**ADDENDUM NO. 4**

Date: September 14, 2018  
Project: **Secondary Treatment Plant Upgrade & Recycled Water Expansion**  
Job No.: 12600-07/16650-02

**SLUDGE TRANSFER MODIFICATION PLAN**

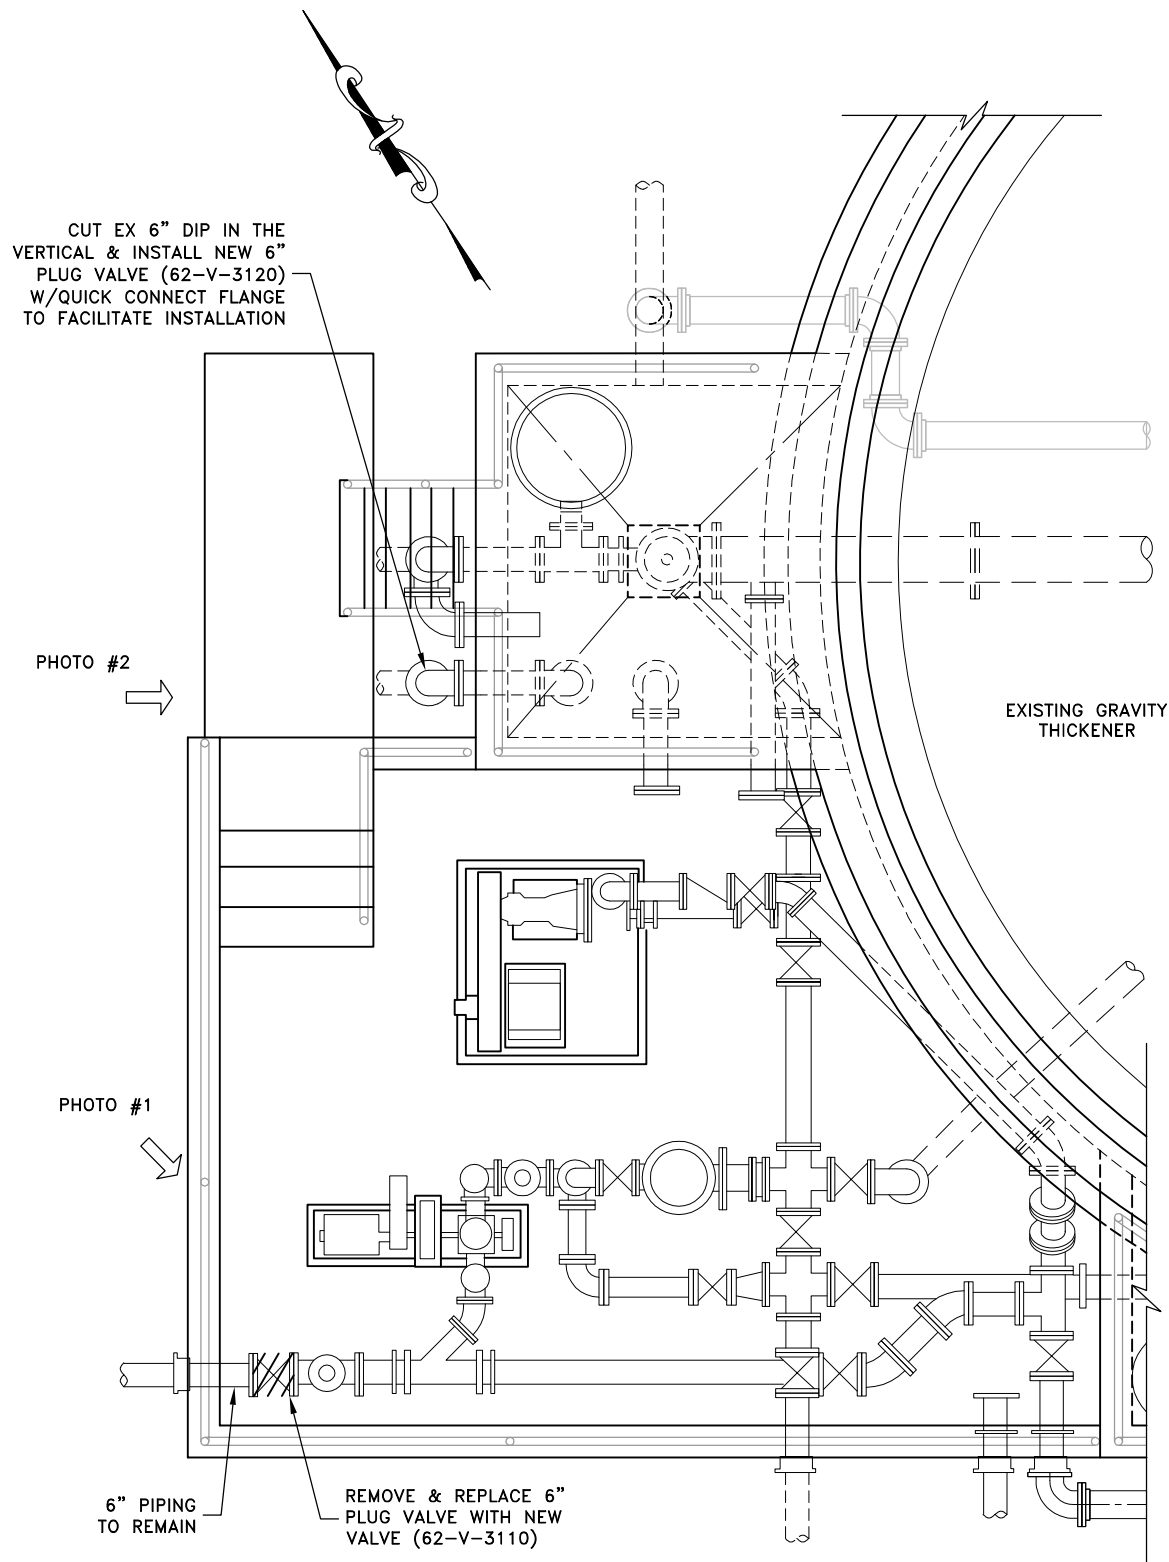
6. **Sheets C-47 and C-48:** The tag number for the gate in the bypass control box should be **23-G-3120** rather than 21-G-3120.
7. **Sheet C-50:** As discussed above, this sheet has been added to provide details on the one (1) replacement 6-inch plug valve and the one (1) new 6-inch plug that are to be installed on an existing 6-inch DIP line. **A copy of this new sheet is provided with this addendum for reference.**

**PRIMARY PUMP STATION  
MECHANICAL PLAN**

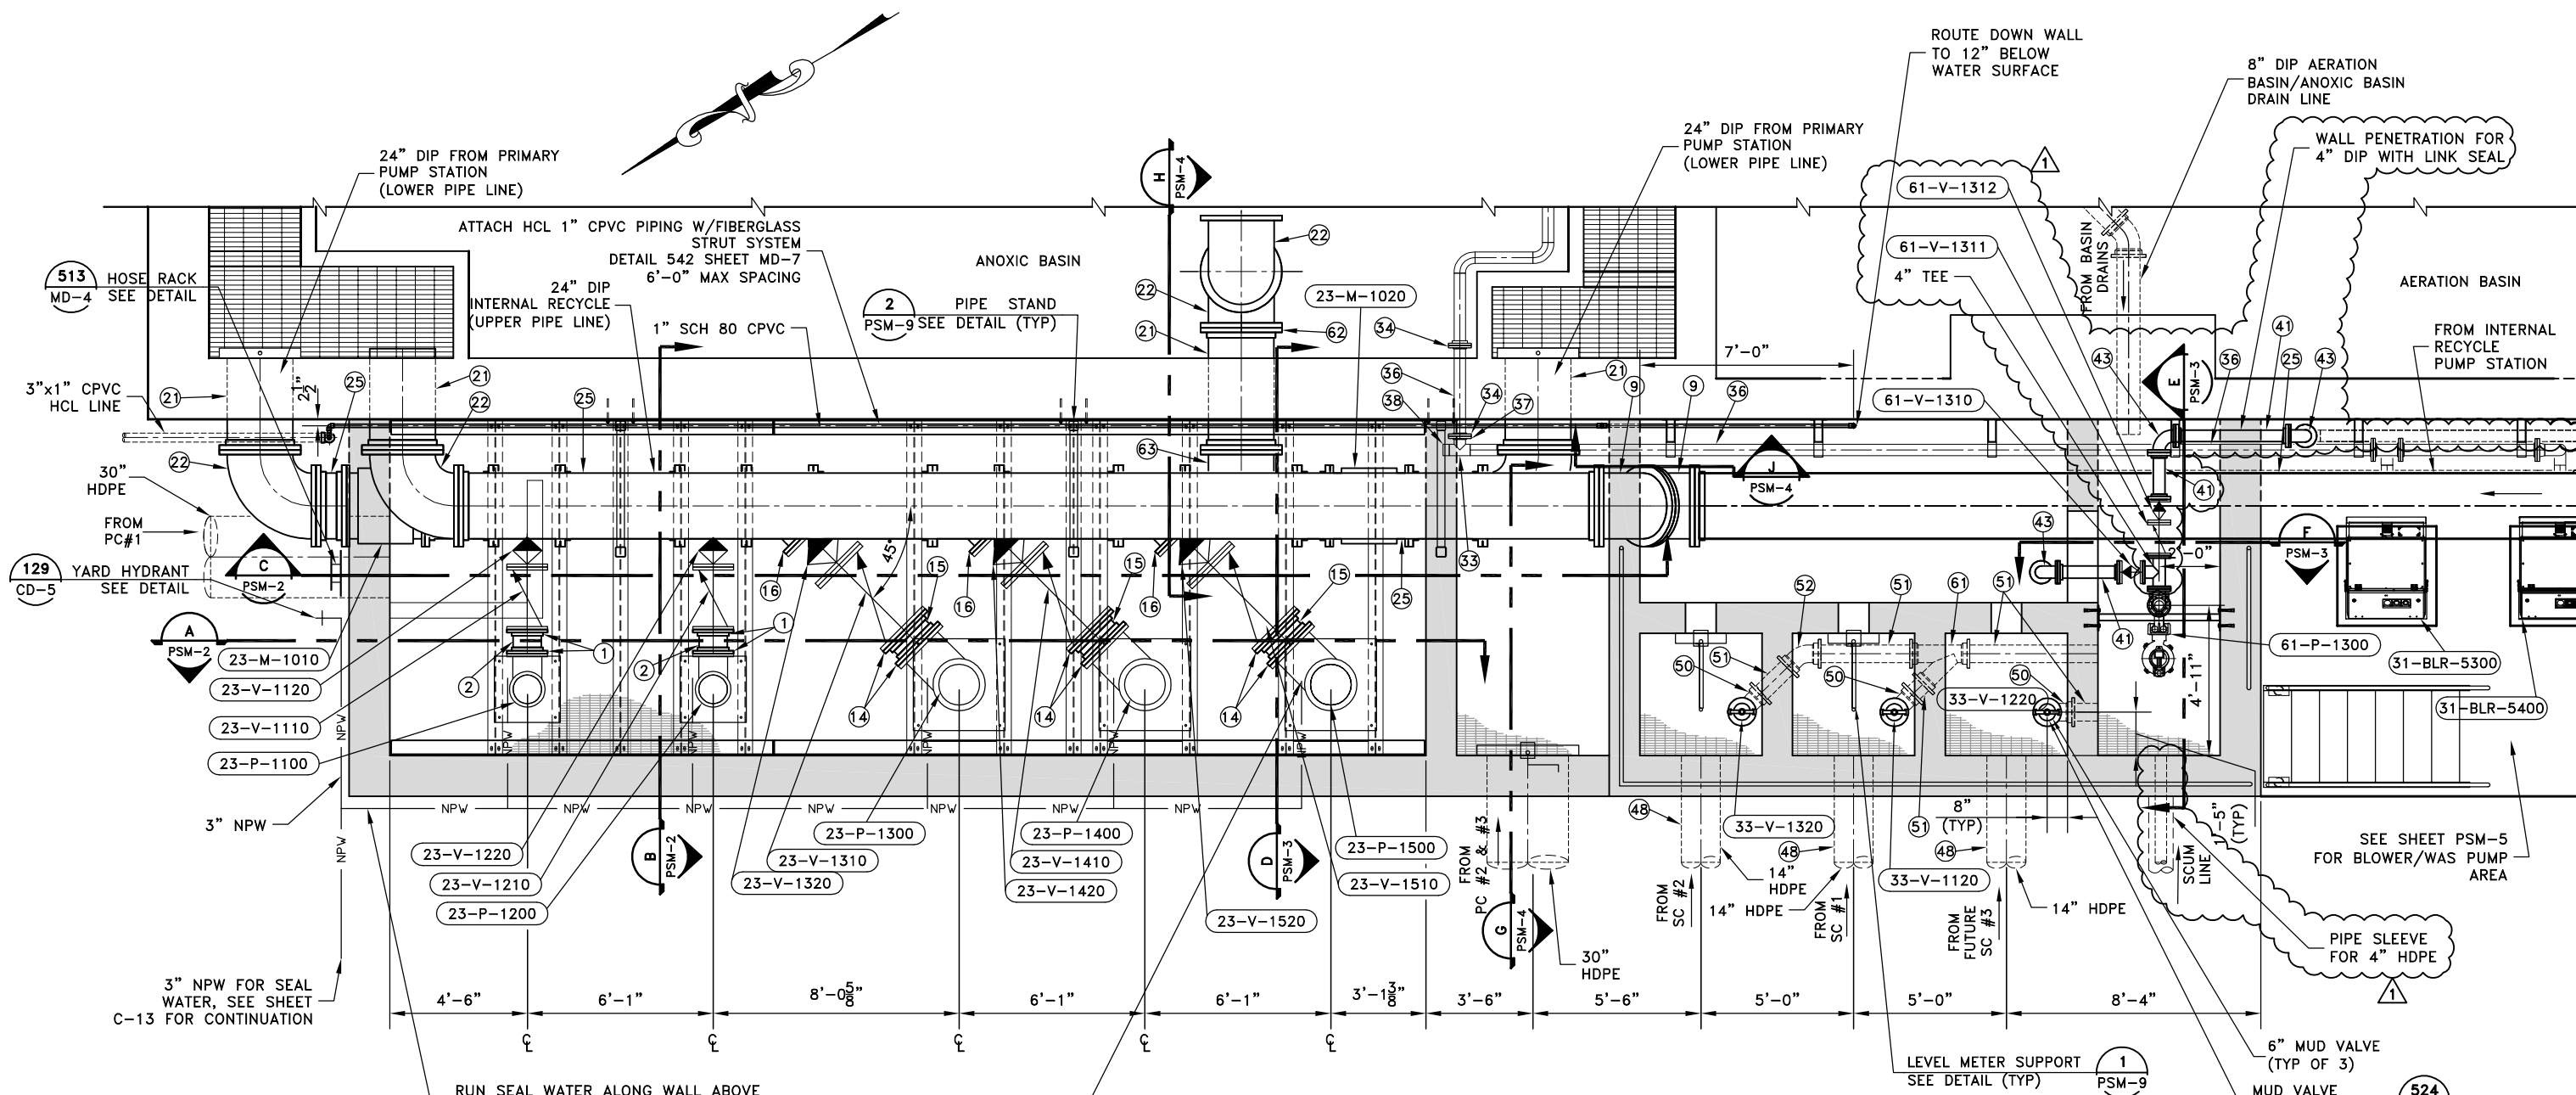
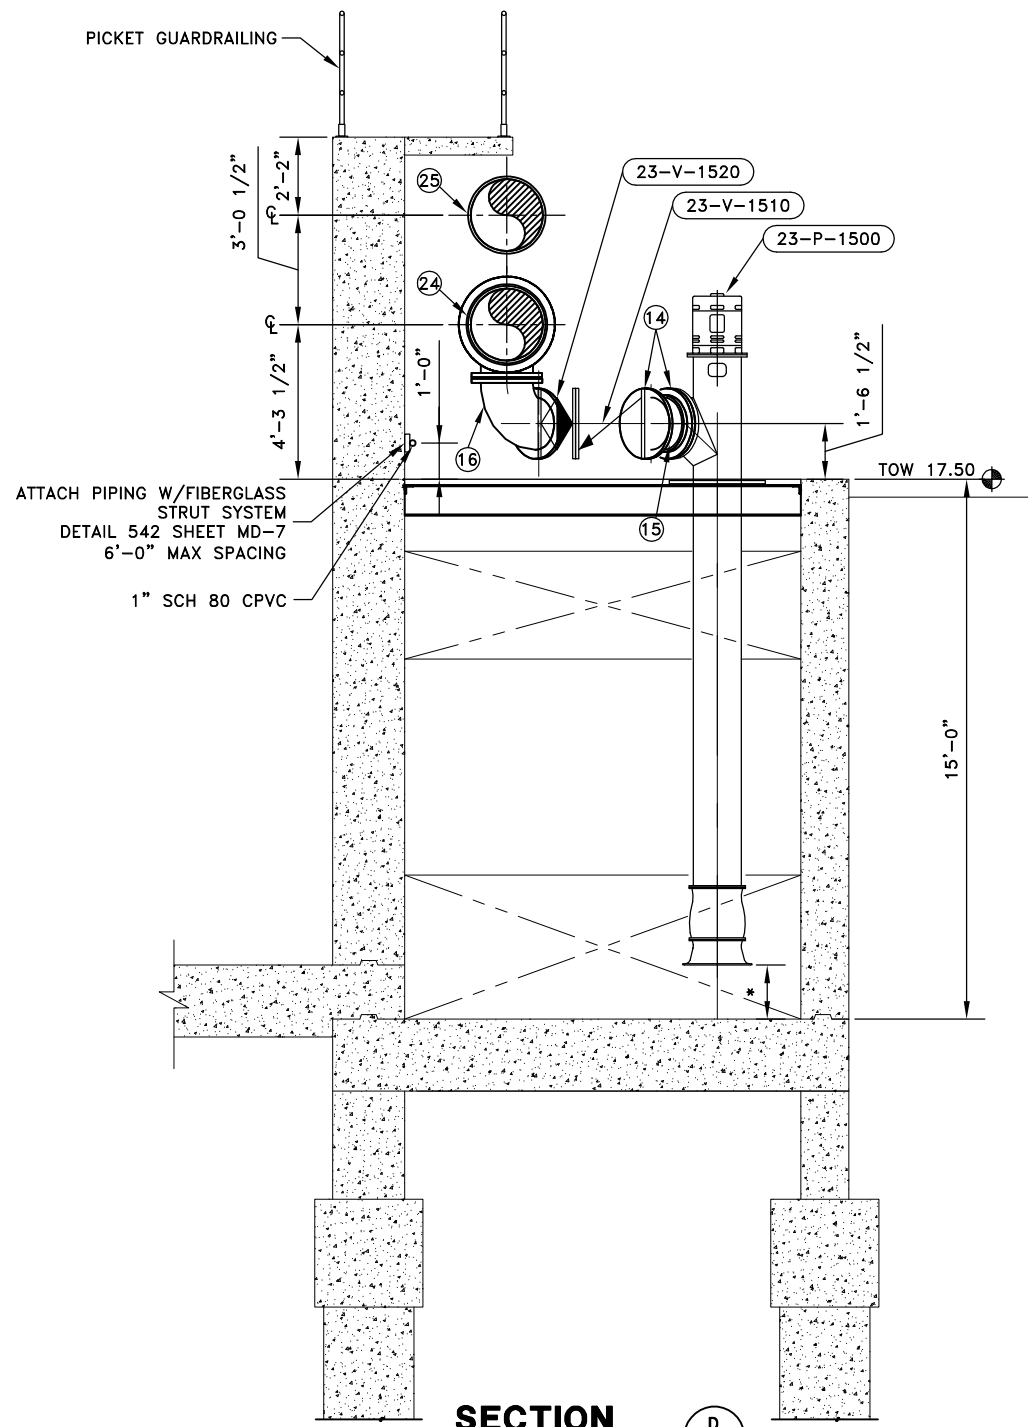
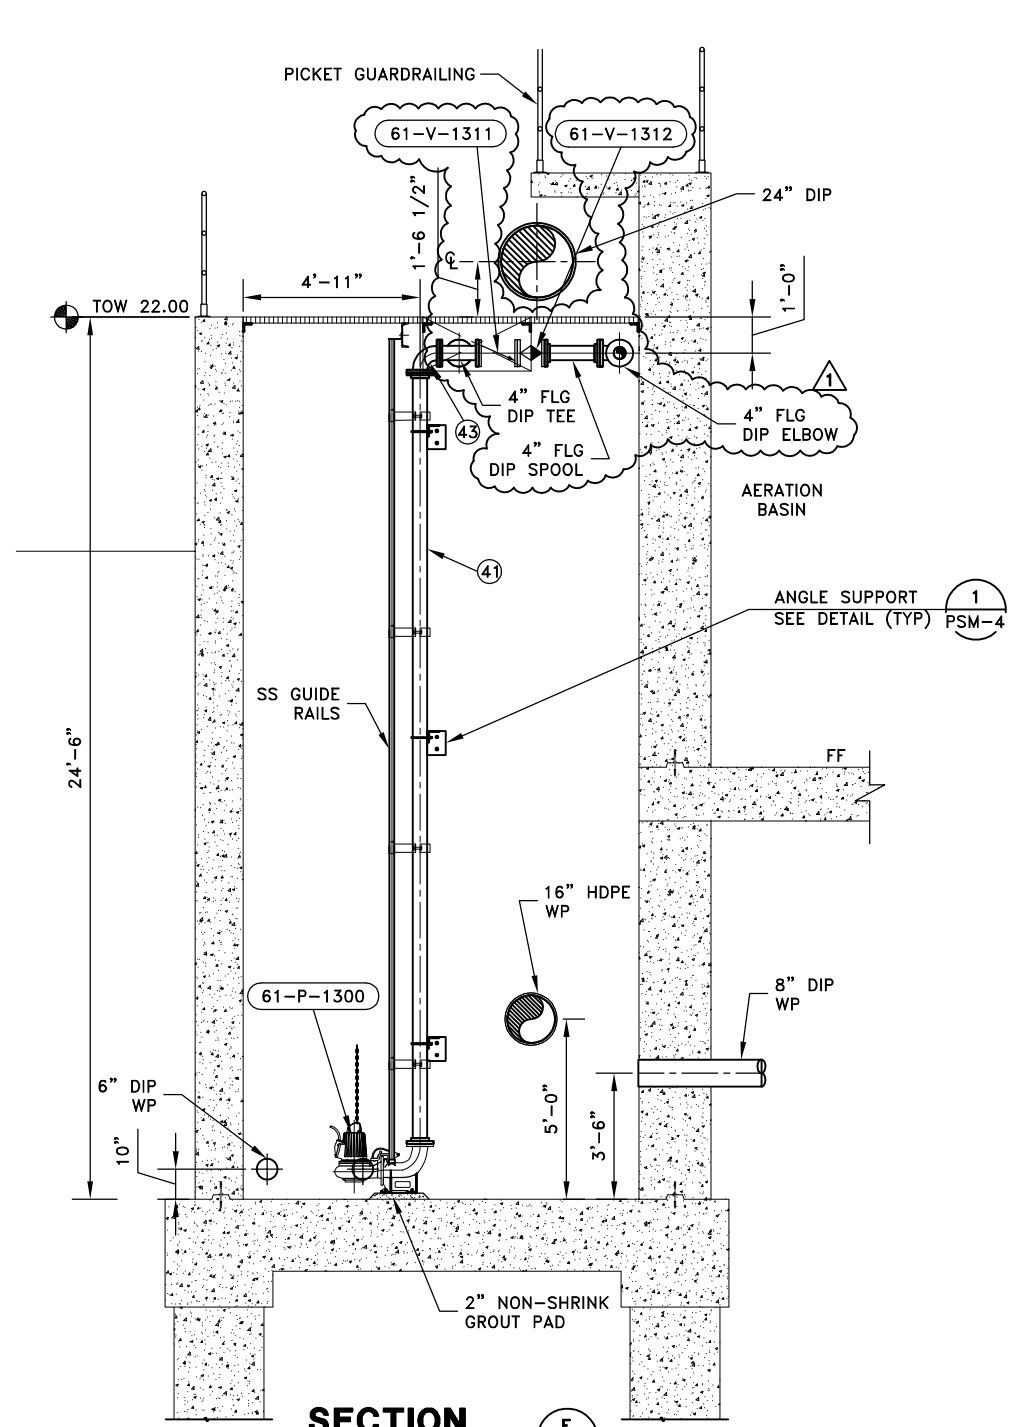
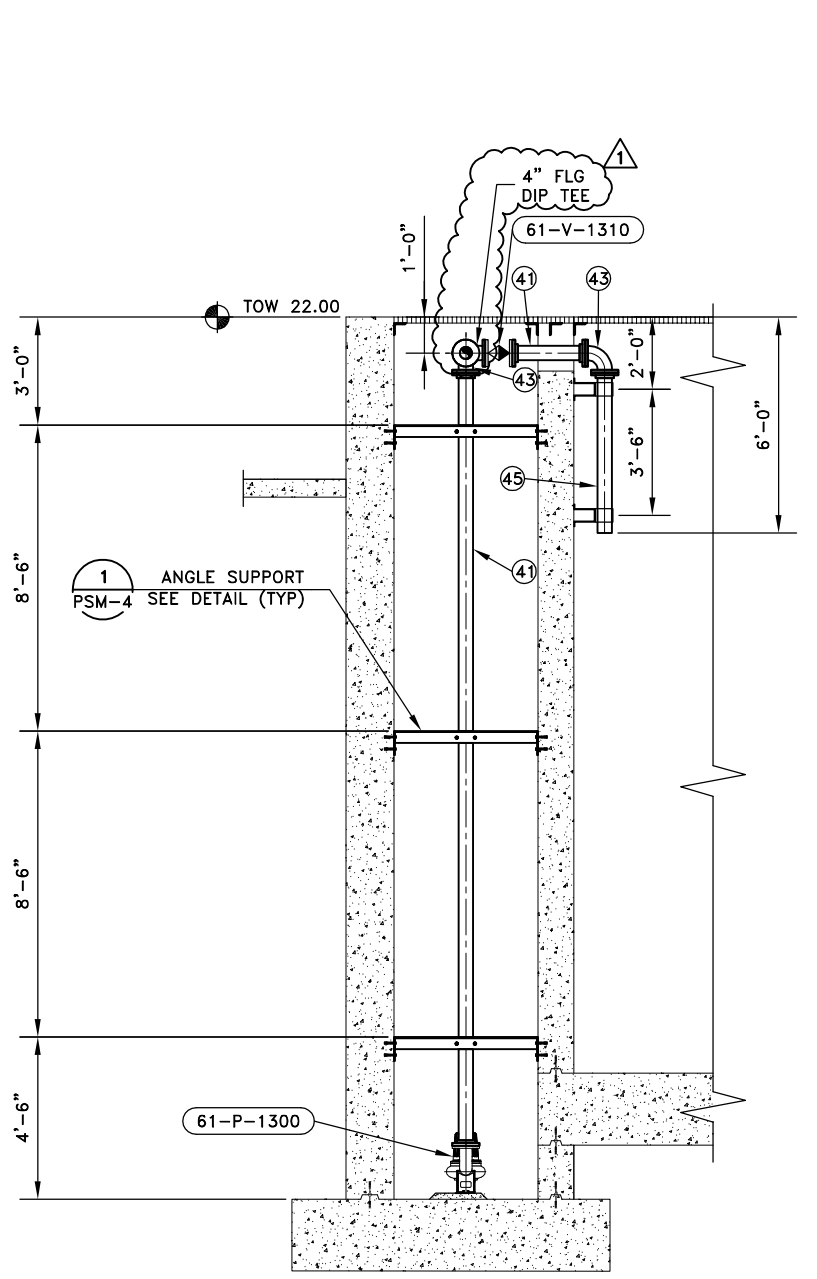
9. **Sheets PSM-1, PSM-3, and PSM-5:** The 4-inch secondary clarifier scum line has been rerouted to feed into the drain box (the deepest basin adjacent to the RAS collection boxes) that houses pump 61-P-1300. The discharge for this pump has been modified to include a second discharge option, including two new valves (check and isolation plug valves **61-V-1311** and **61-V-1312** respectively) and an additional 4" DIP/HDPE discharge line that connects to the WAS pump discharge line below grade. These sheets have been modified to show the new route of the 4" scum line and the new discharge line/valves associated with the drain pump. Note that other drawings in the PSM area will be updated to reconcile with this change for the construction set. **Revised versions of these sheets are provided as an attachment to this addendum for reference.**
